Product Change Notification / ALAN-15FPNL260

eSign# E000077600 Final Notice: Implement change of memory density from 4GB to 2GB on selected Microsemi M2GLxx, RT4Gxx and 5962-16xx device families available in various packages.

Customer Notification (CN)

Subject: RTG4, SmartFusion2, and IGLOO2 DDR Controller Memory Density Support

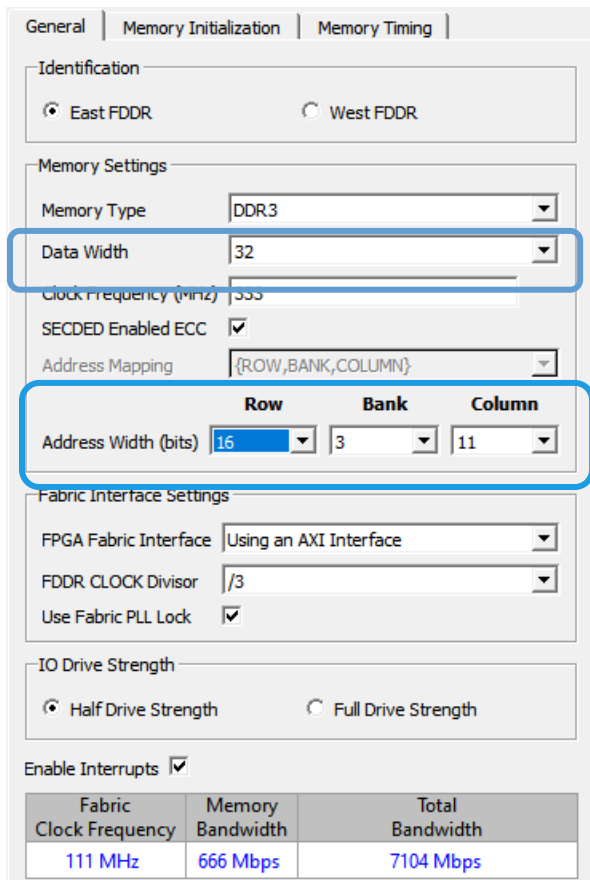
A functional issue has been identified where the FDDR/MDDR configured to support 4GB was unable to access the entire 32-bit AXI address range. Analysis of the FDDR/MDDR hard-IP block design has determined the LPDDR/DDR2/DDR3 Row, Bank, Column address space is limited to 2GB and not 4GB as originally indicated in Libero SoC Software and documented in the RTG4, IGLOO2 and SmartFusion2 Product Briefs and DDR Memory Controller User Guides.

FDDR/MDDR that are configured to access a 4GB DDR memory space (that configures MSB of the 32-bit AXI address to the 4GB DDR memory address) will generate incorrect DDR memory addresses whenever the MSB of the AXI address is asserted. This scenario will result in functional errors in simulation and hardware testing. Designs must not use a DDR memory organization that will exceed a 2GB AXI address to access the entire memory space.

FDDR/MDDR configurations that do not map the MSB of the 32-bit AXI address to the DDR memory address are not affected. In other words, if the AXI address does not exceed a 2GB address space, there is no application impact. Designs with memories greater than 2GB can only access up to 2GB of the memory.

No action is required for designs that do not address more than 2GB with the FDDR/MDDR controller hard-IP blocks in RTG4, IGLOO2, and SmartFusion2.

For designs experiencing the functional issue described above, or those planning to address more than 2GB, the following conditions must be reviewed:

- Ensure that the Libero FDDR/MDDR configuration does not map the AXI address to a 4GB DDR memory address.

- Designs with memories greater than 2GB can only access up to 2GB of the memory.

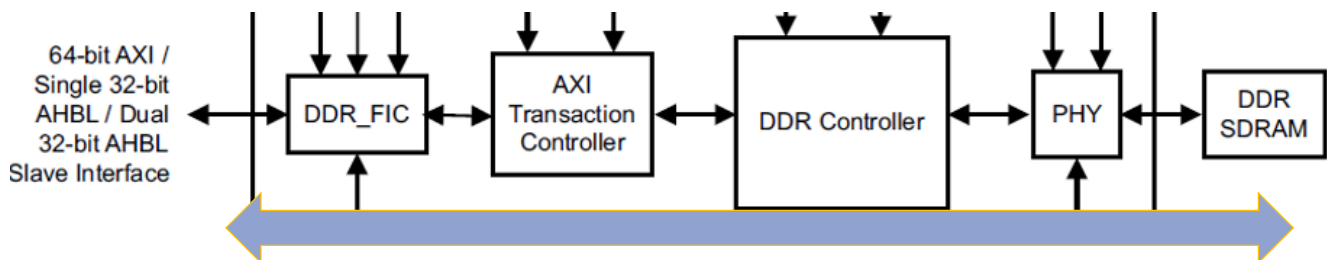
How to assess if configuration of memory controller is addressing more than 2GB.

From the Libero Configurator, below

- Total LPDDR/DDR2/DDR3 address bits = Row+ Bank + Column
- Total LPDDR/DDR2/DDR3 addressable data bits = $2^{\text{address bits}} * \text{(word size aka Data Width)}$
- Total LPDDR/DDR2/DDR3 addressable bytes = $(\text{addressable data bits})/8$

Example: Row = 16, Bank = 3, Column = 11

Total LPDDR/DDR2/DDR3 address bits = 30

Total LPDDR/DDR2/DDR3 addressable data bits = $2^{30} * 32 = 34,359,738,368$

Total LPDDR/DDR2/DDR3 addressable bytes = $34,359,738,368/8 = 4,294,967,296 = 4GB$
